Re: Initial Submission Review: Skydance – Master Plan Amendment
Case Number: 2021-7007-01

Initial Submission Review

To: Dean Kaiser, City of Aurora, Transportation Engineering Department
From: Cassie Slade, PE, PTOE
Date: April 2, 2024
Project: Skydance Relocation of Units (Aurora, Colorado)
Subject: Traffic Analysis Memo

Figure 2. Map from Skydance Master TIS for Proposed Relocation of Multi-Family Units

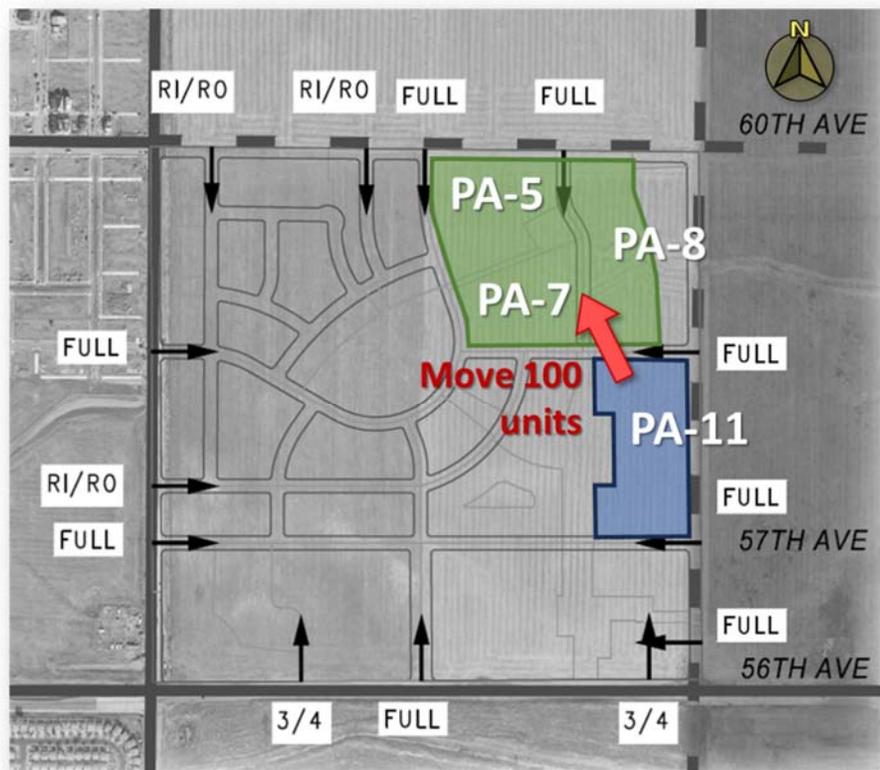
Clean up overlap

Fixed.

Figure 4 – Rerouted Site-Generated Trips for 100 Multi-Family Units

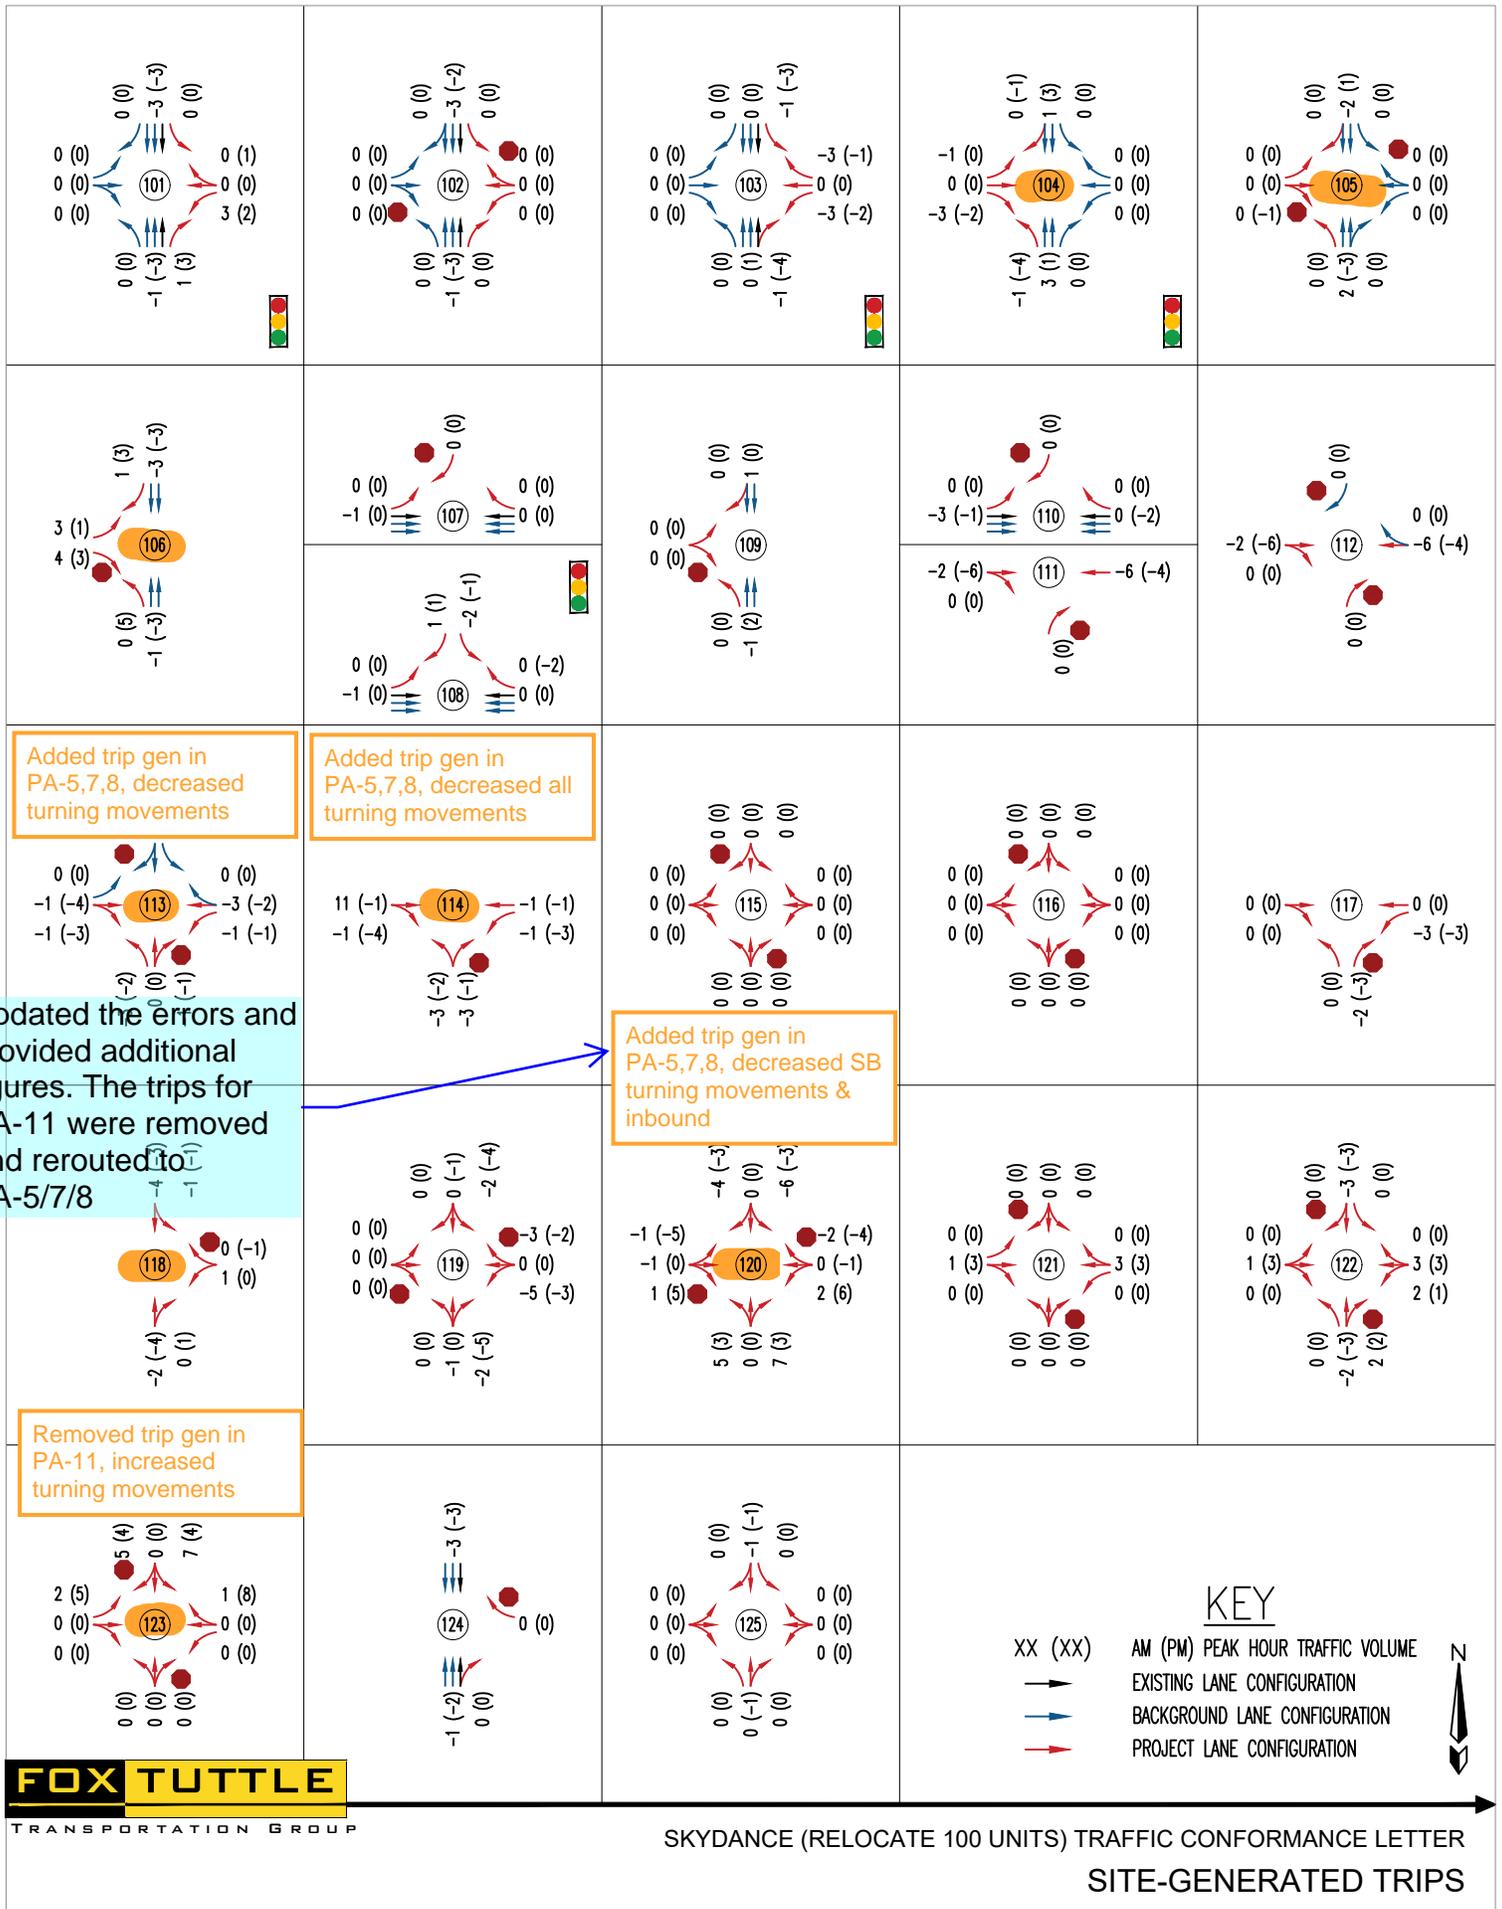
2024-05-29 (DJK) reviewed, minor editorial comment page 2, do question the Fig 4 turning movement trip gen differentials with relocation off 100 units from PA-11 to PA-5,7,8. (page 3 comments) Review and provide response.

Note Fig 4 comments, the reduction of trip gen in PA-11, increase of trip gen in PA 5,7,8 seem contradicting in the Trip Gen turning movement assignments at the key intersections.

Note, can concur that the differential is very negligible at the intersections in question compared to the MTIS Fig 8B values provided.

Please provide a bit more explanation of trip gen differentials before we accept this letter.

2024-06-19 (CRS) Thank you for your thorough review. Apologies for the errors in the trip volumes, it was an oversight and has been fixed. Additional figures have been provided to allow the reviewer to follow the changes for removal of PA-11 trips and the reroute to PA-5/7/8.

Updated the errors and provided additional figures. The trips for PA-11 were removed and rerouted to PA-5/7/8

Skydance - Master Plan AURORA, CO

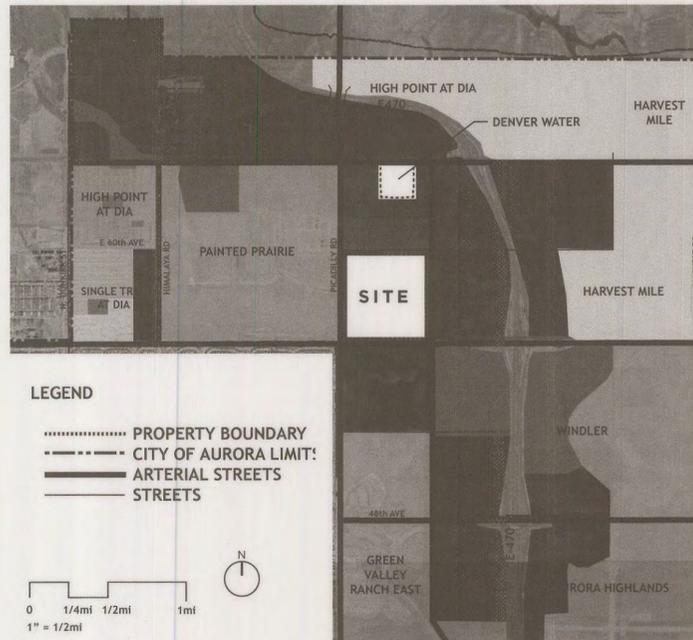
1A. Please remove the amendment date from the Cover Sheet of the mylars. This will be added by staff with the minor amendment is approved.

Remove date on this; will be added by staff when the MA is approved

Response: The amendment date has been removed from the cover sheet of the mylars.

Date has been removed
